# California High-Speed Train Project

**Agreement No.: HSR 13-06  
Book 3, Part B, Subpart 5**

## **Design Variance Request Process**

CALIFORNIA HIGH-SPEED TRAIN PROJECT  
DESIGN VARIANCE REQUEST

Figure 1: Additional Property Impacts, Second Street

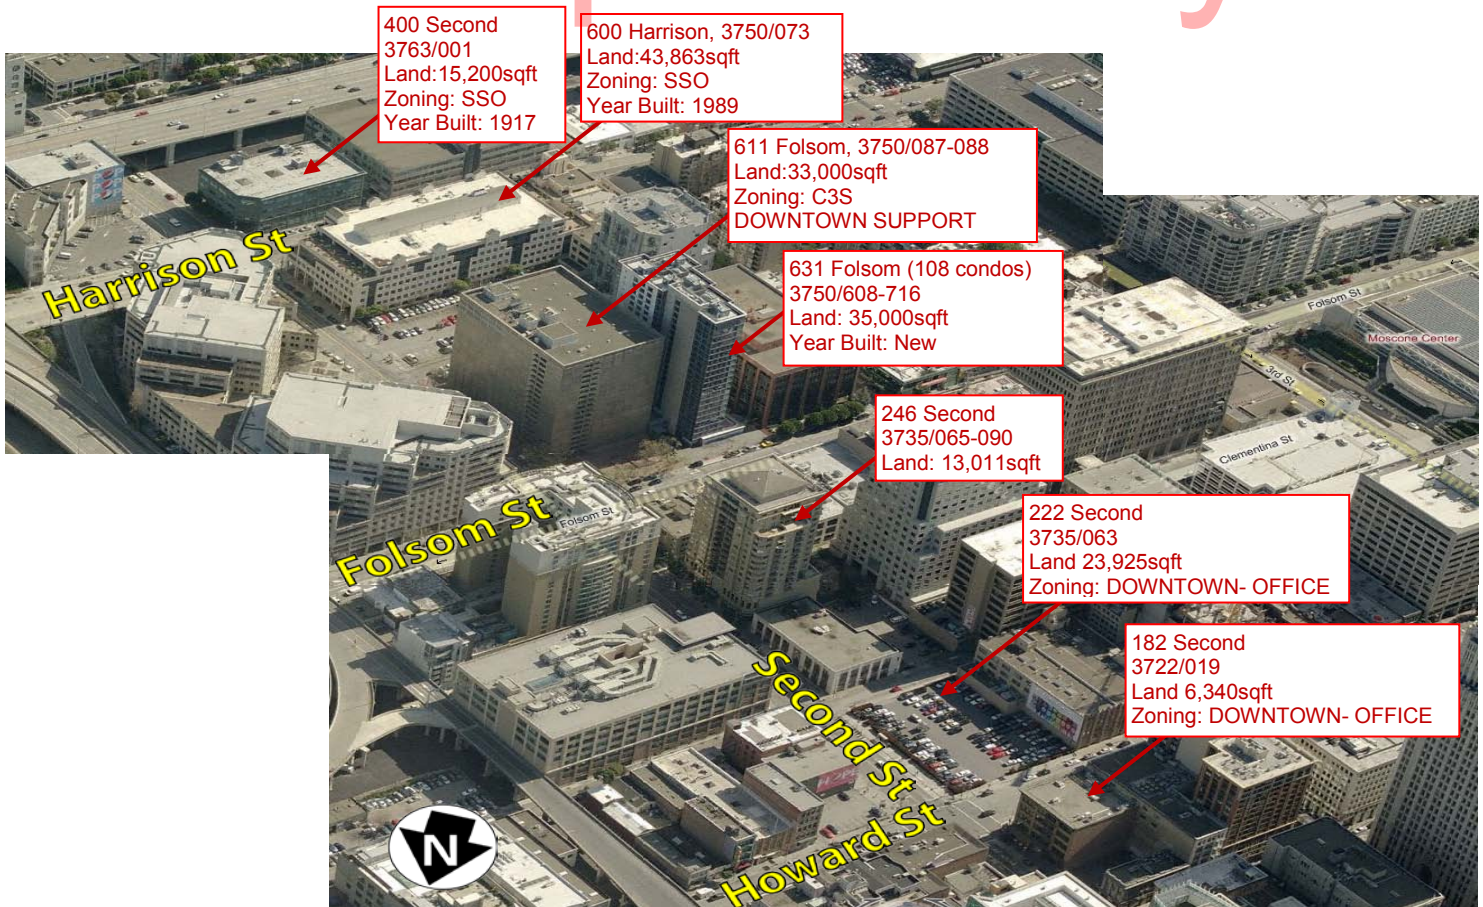
Properties not currently identified for acquisition which would be impacted by accommodating CHSTP criteria for platform approach tangent length are indicated in Figure 1 below. Costs associated with the acquisition of these properties and the relocation of owners is provided in Table 1.

**SAN FRANCISCO DOWNTOWN RAIL EXTENSION  
HIGH SPEED RAIL AND CALTRAIN ACCOMMODATION  
TTC TRACK CONFIGURATION  
SEPTEMBER 20, 2010**

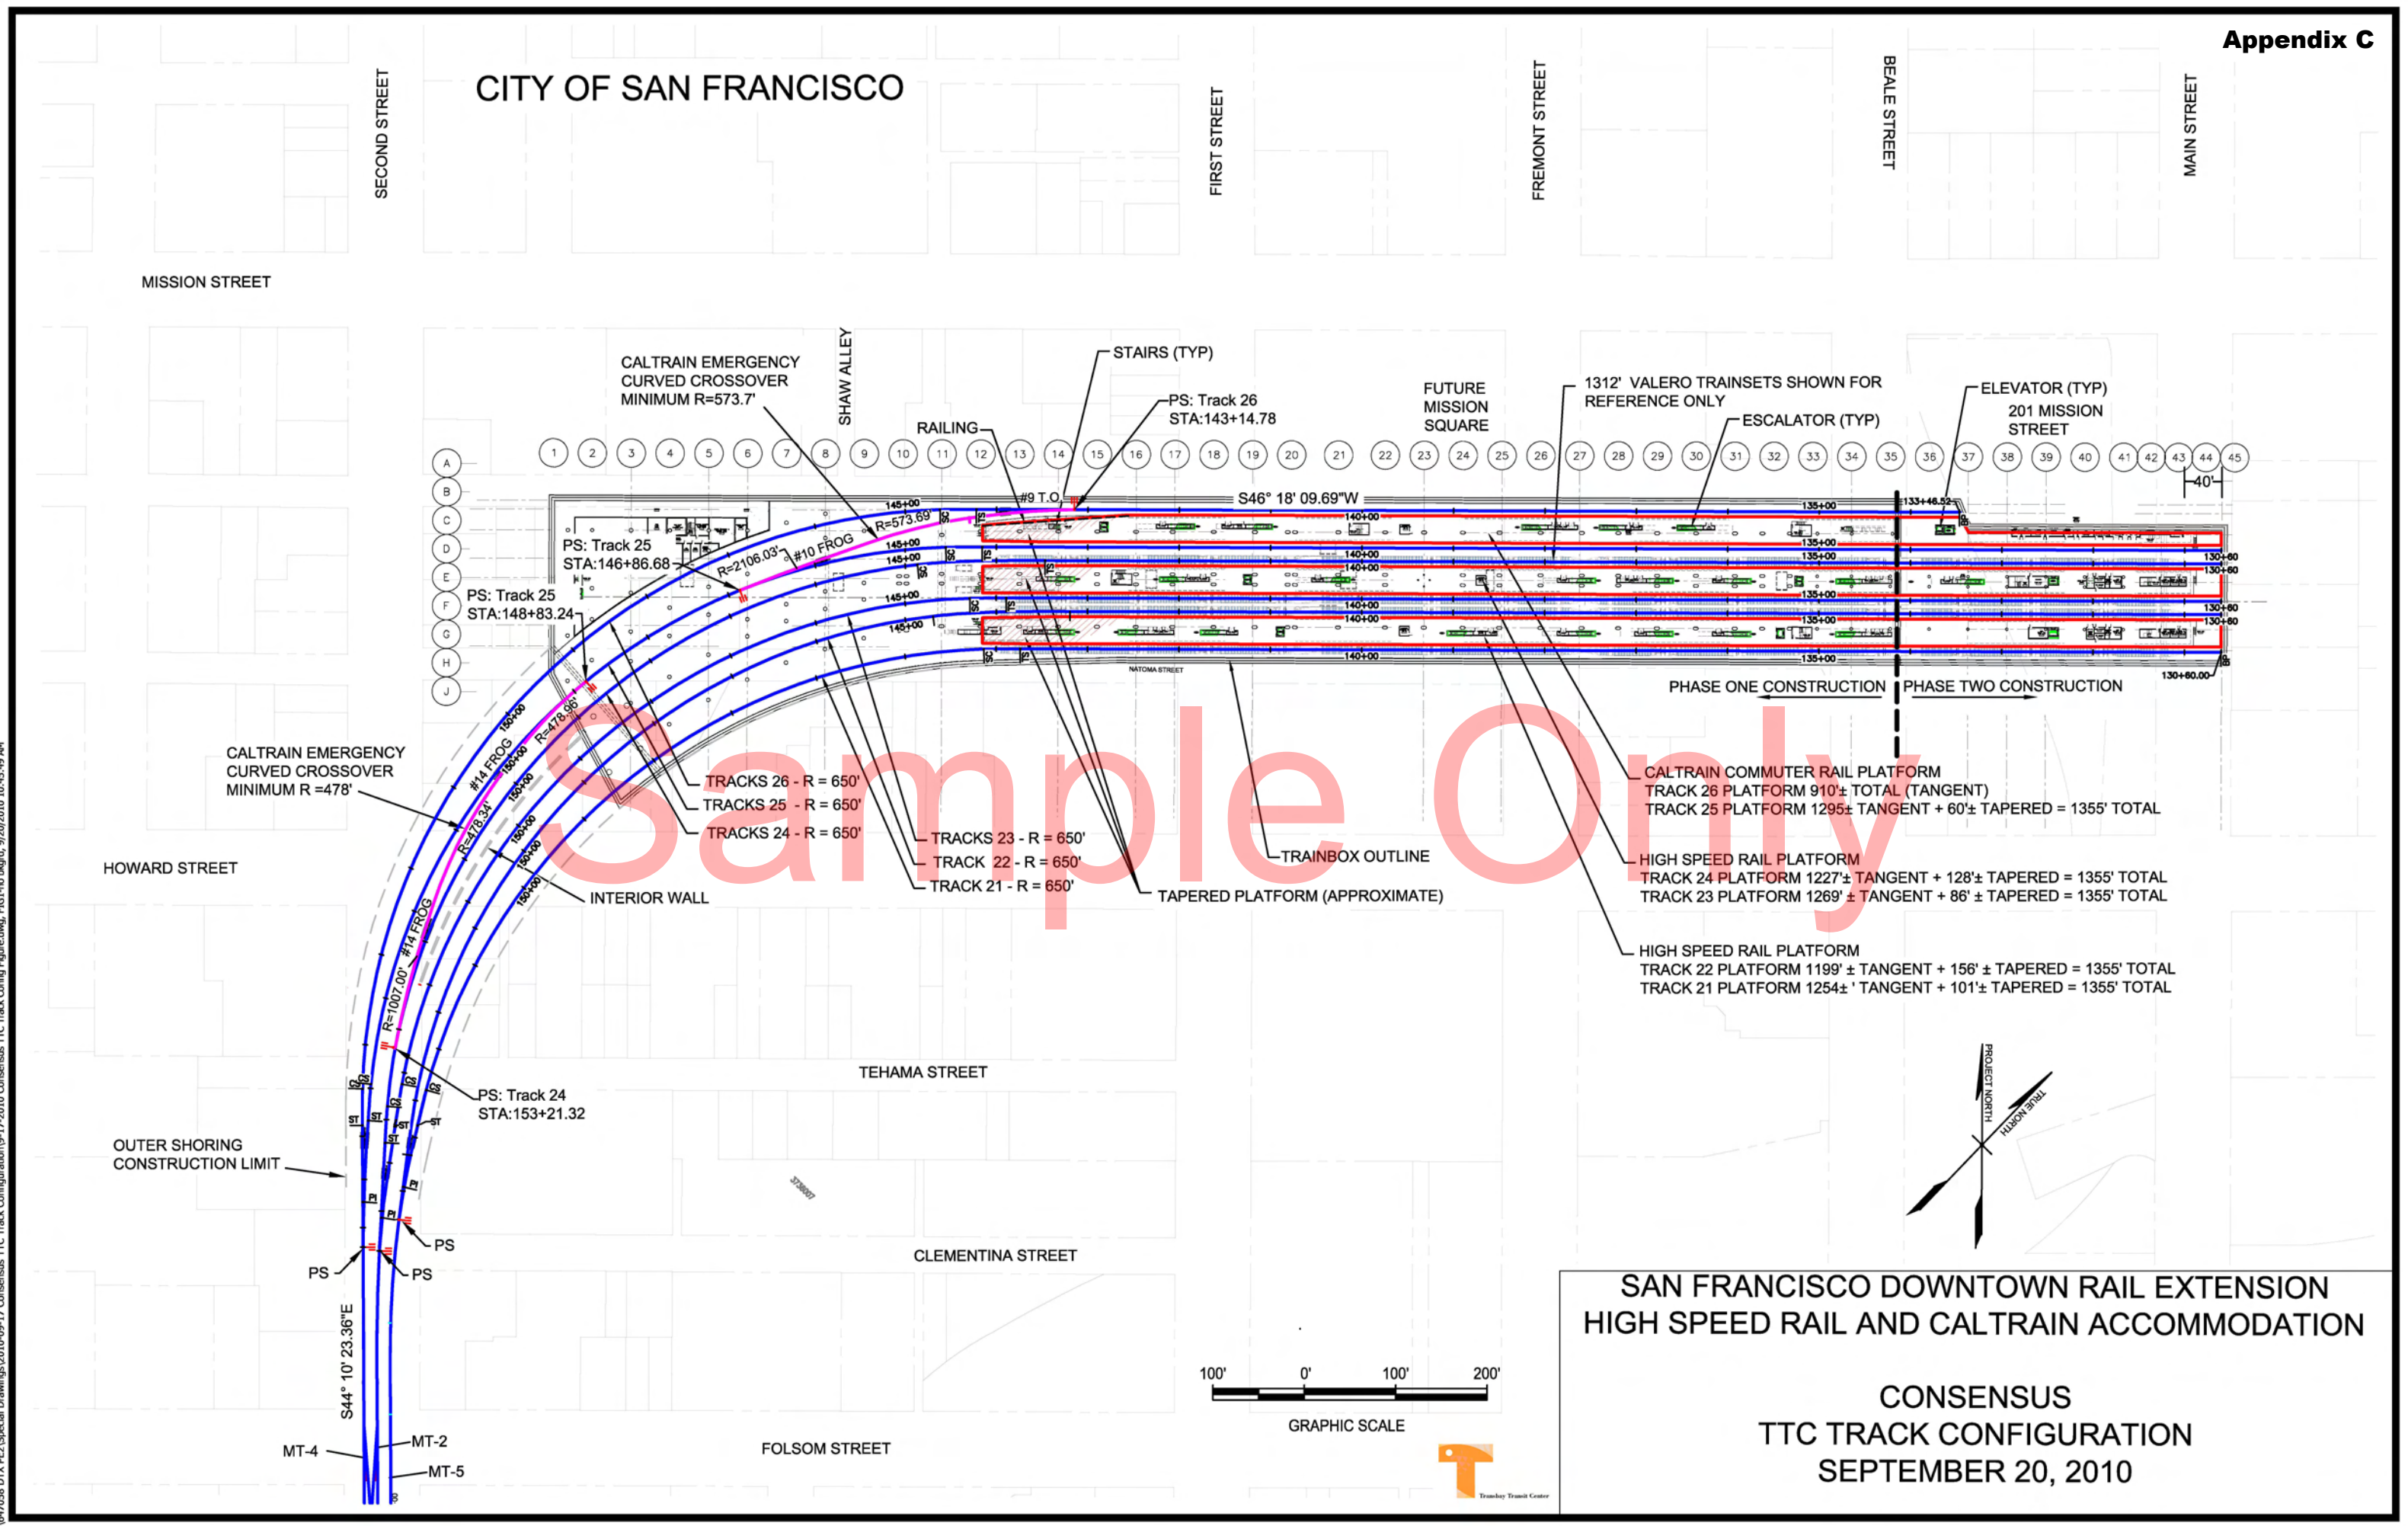
More specifically, it is understood that the attached exhibit is a preliminary drawing and further design is required to address areas where engineering variances are required. Specific variances required for the CHSR platforms were indicated in a letter by Parsons Brinkerhoff dated August 27<sup>th</sup>, 2010 (Reference PB-TJPA-1127). In addition, engineering variances will be required by Caltrain for the crossovers required in the curved portion of the terminal approach; the reduced width of platform on Track 25 near the end post; and the tapered end of platform on Track 26- understood to be outside of the usable portion of vehicle berthing.
